ATTACHMENT A

PROPOSED TECHNICAL SPECIFICATION AMENDMENTS

Figure 2.1-1 Reactor Core Thermal and Hydraulic
Safety Limits, Three Loop Operation

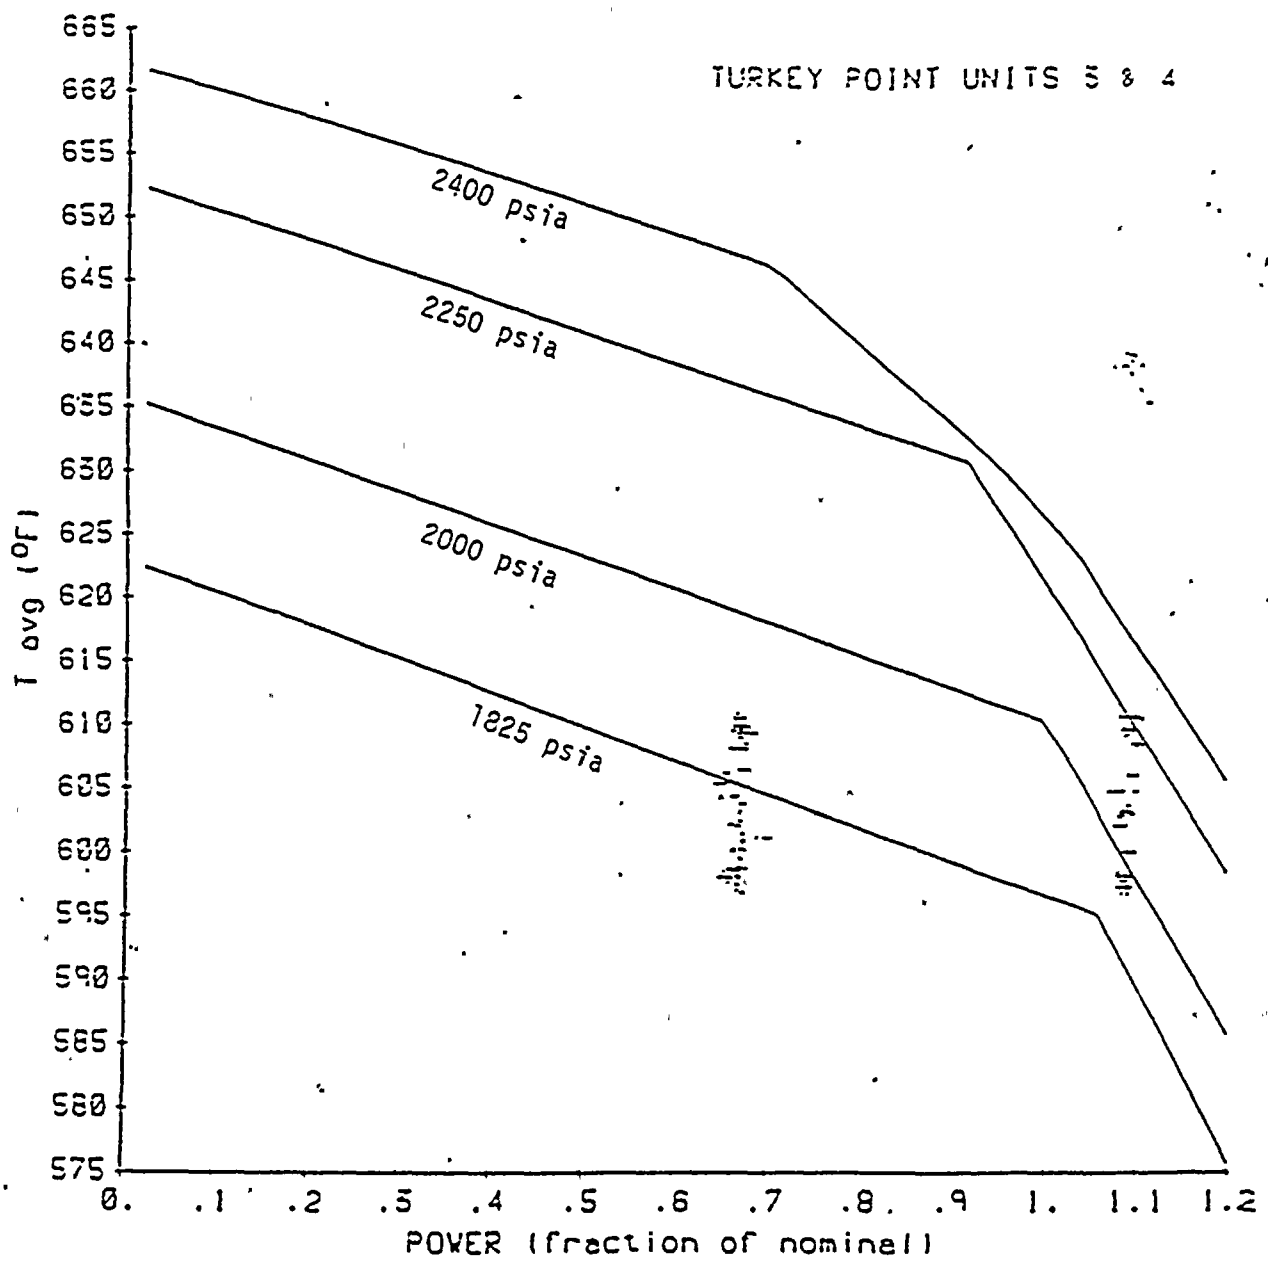
<u>Figure</u>	<u>Title</u>
2.1-1	Reactor Core Thermal and Hydraulic Safety Limits, Three Loop Operation
2.1-1a	Deleted
2.1-1b	Deleted
2.1-2	Reactor Core Thermal and Hydraulic Safety Limits, Two Loop Operation

FIGURE 3.2-3

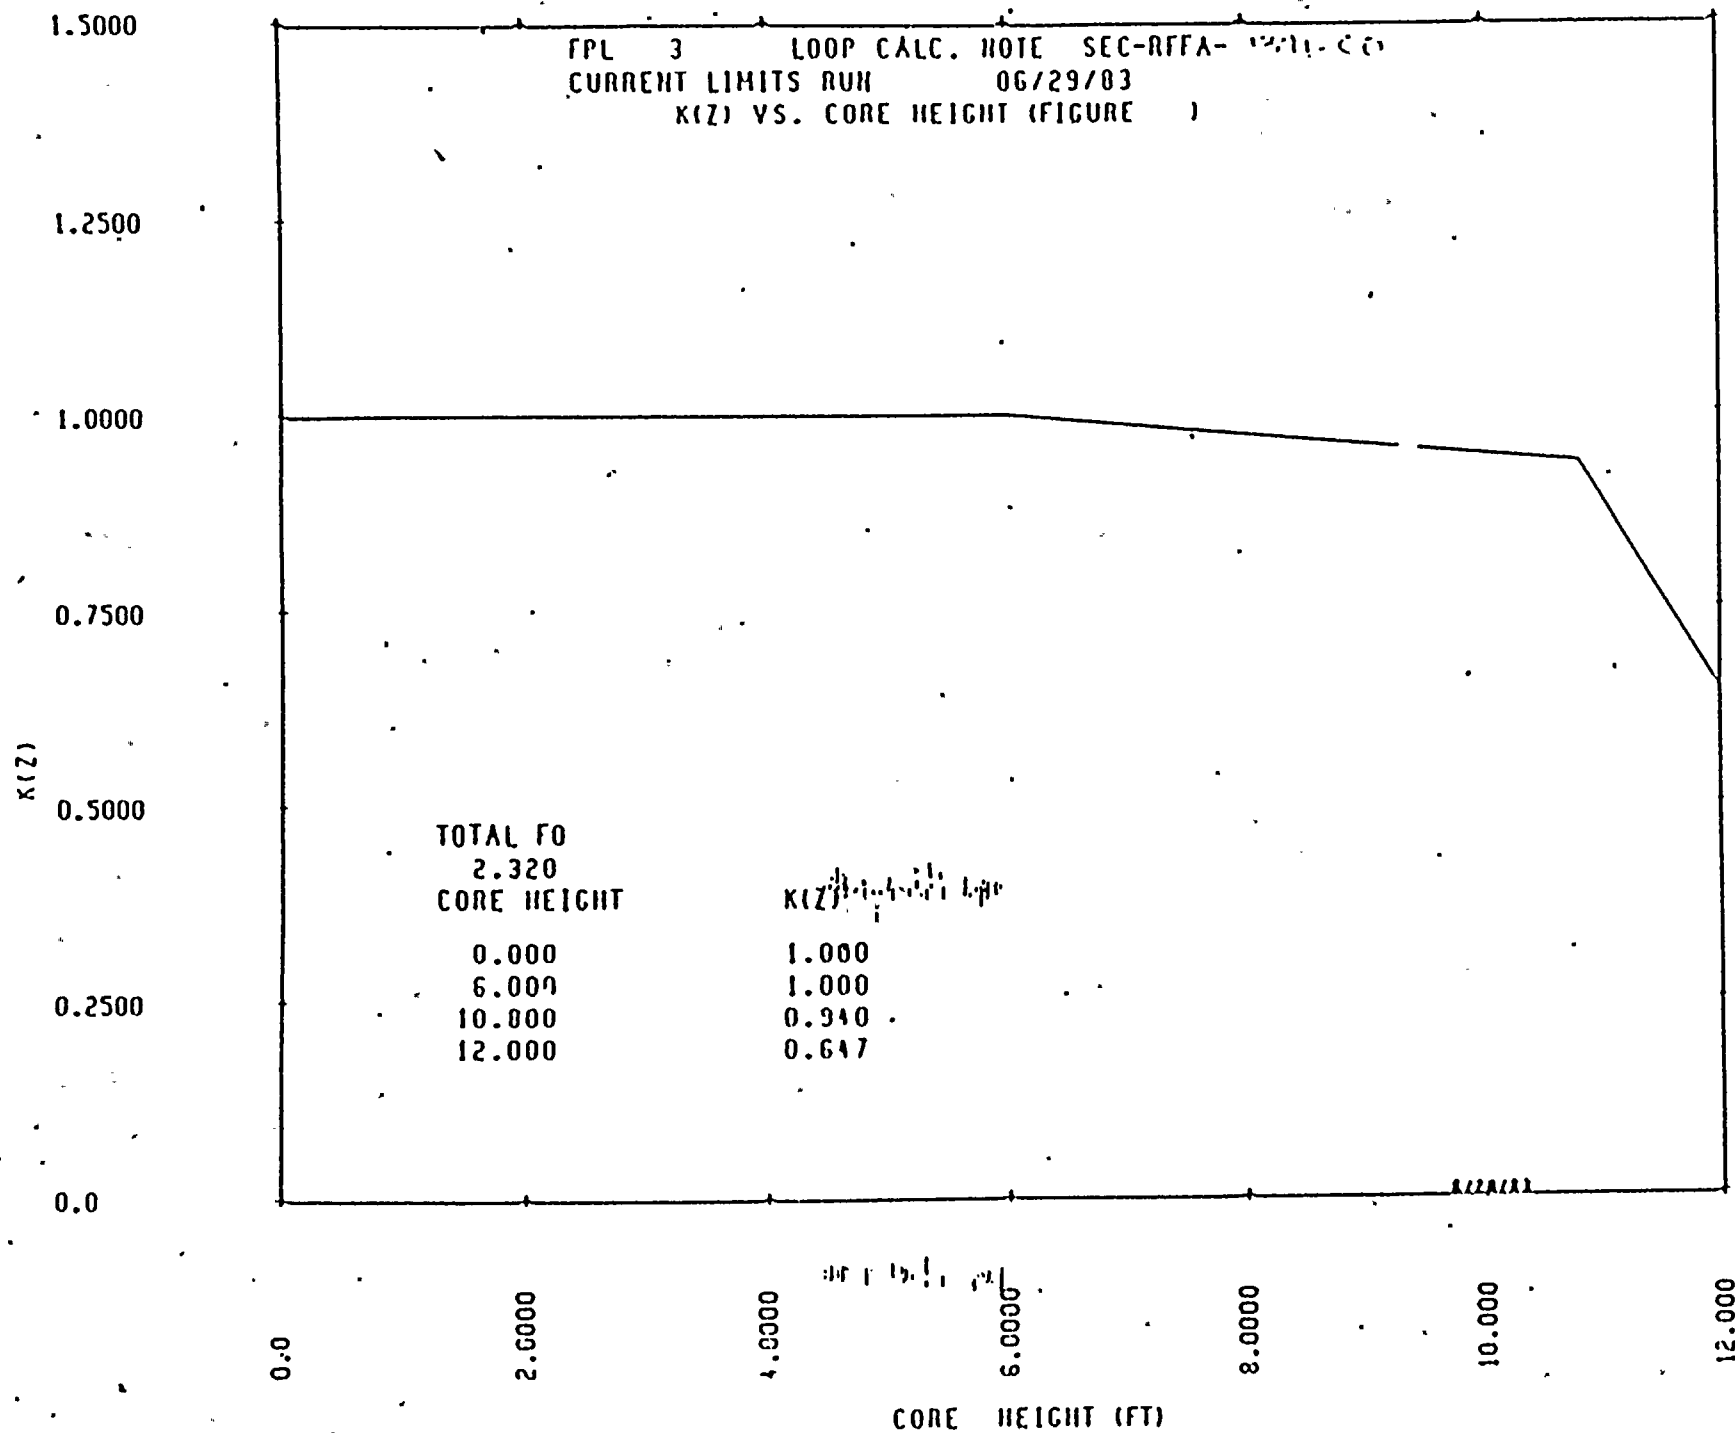
Where P is the fraction of rated power at which the core is operating; $K(Z)$ is the function given in Figure 3.2-3; Z is the core height location of F_Q .

Plugging level	$[F_Q]_L$	Figure Number for $K(Z)$
$\leq 5\%$	2.32	3.2-3
